To: T10 Technical Committee
From: Bob Sheffield (Robert.L.Sheffield@intel.com)
Date: 24 August 2006
Subject: 06-386r0 SAS2: Store-and-Forward Expander Devices

Figure 10 — Aggregation relationships in class diagrams

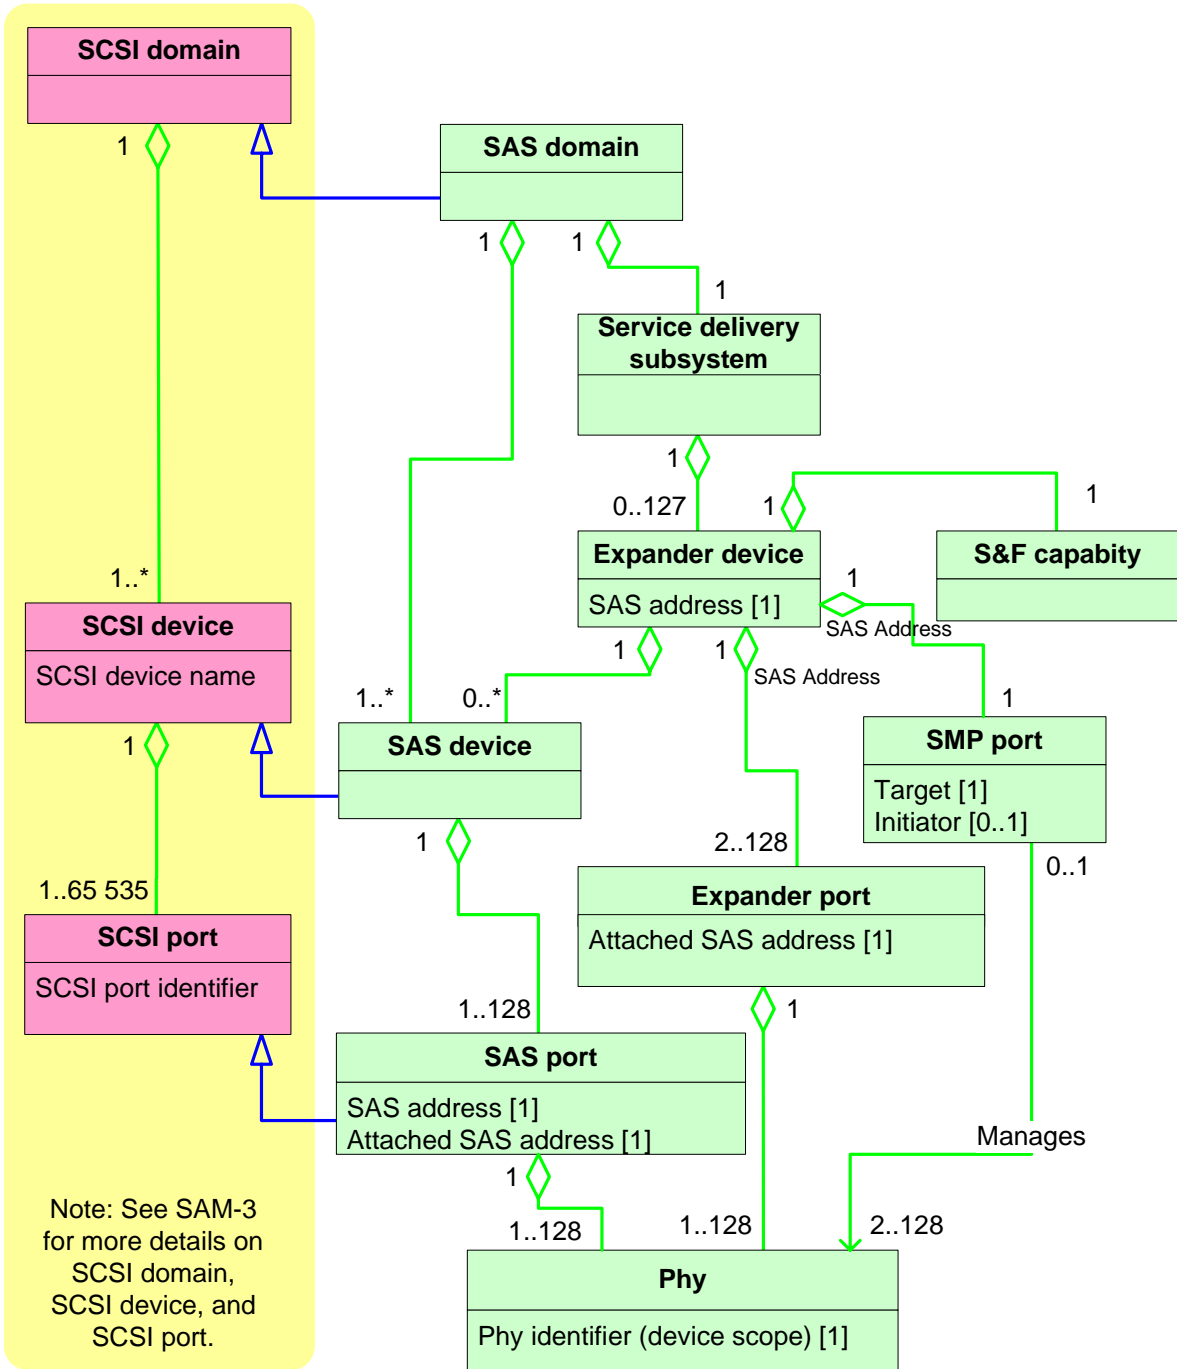
Modify figure 10 as shown to add S&F capability:

Editor's Note 3: Added S&F Capability class

Figure 18 — Expander device

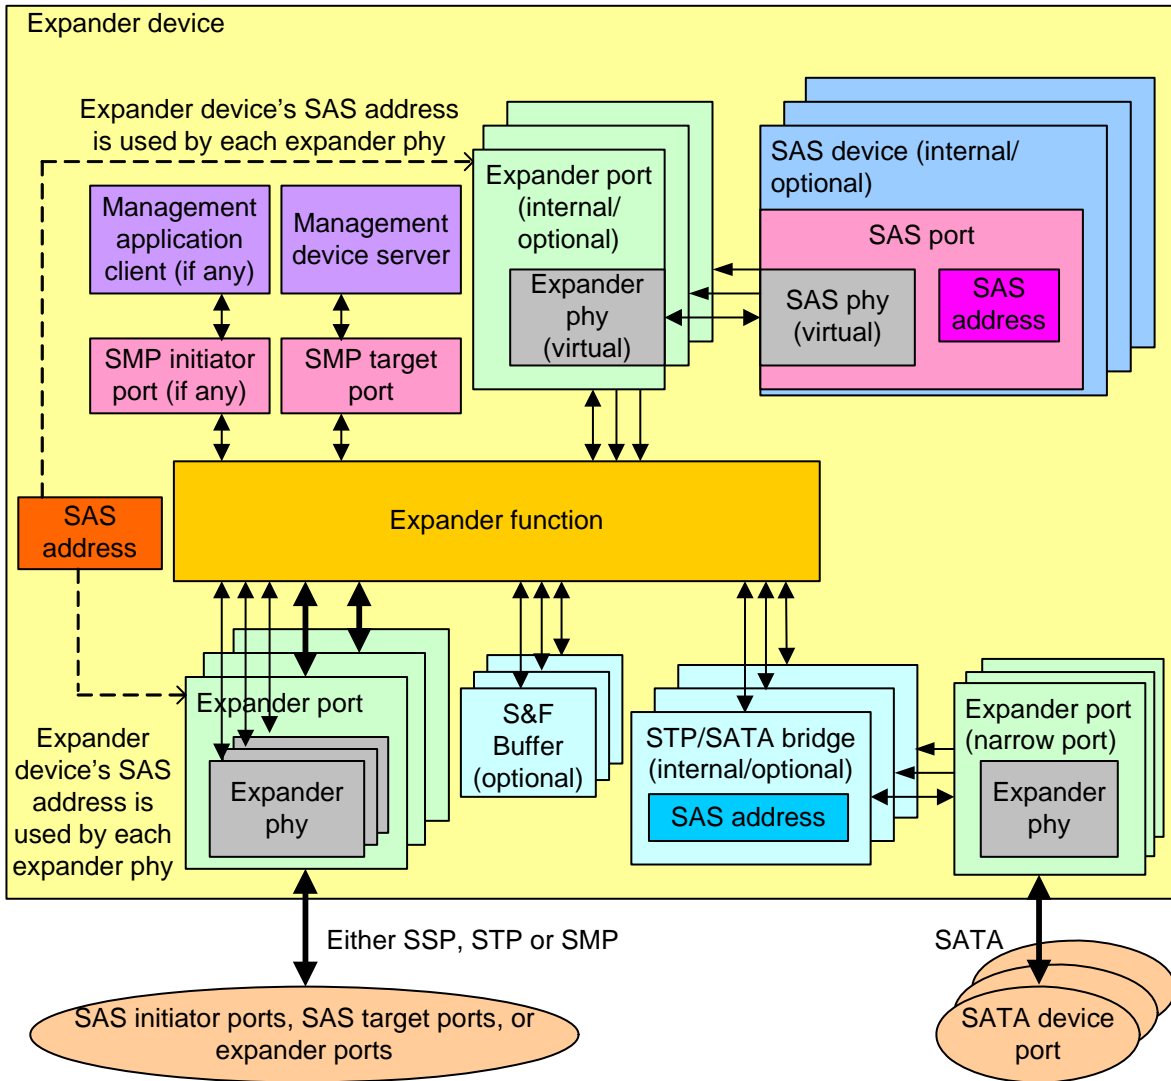
Editor's Note 4: Added S&F Buffer (optional) block

Figure 28 — State machines for SAS devices

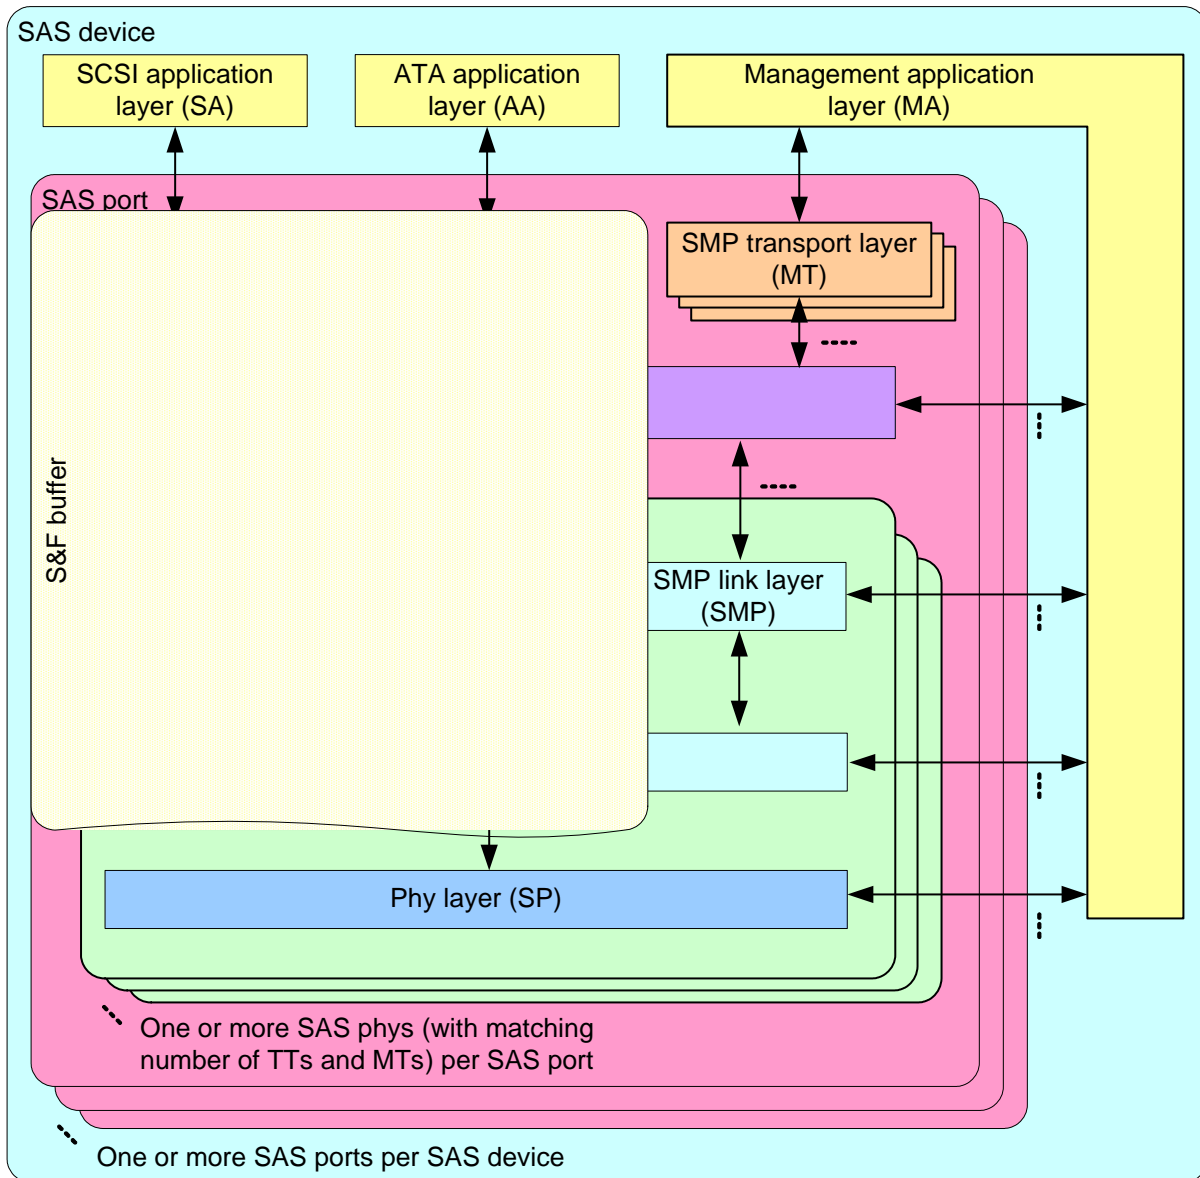
Modify figure 28 as follows:
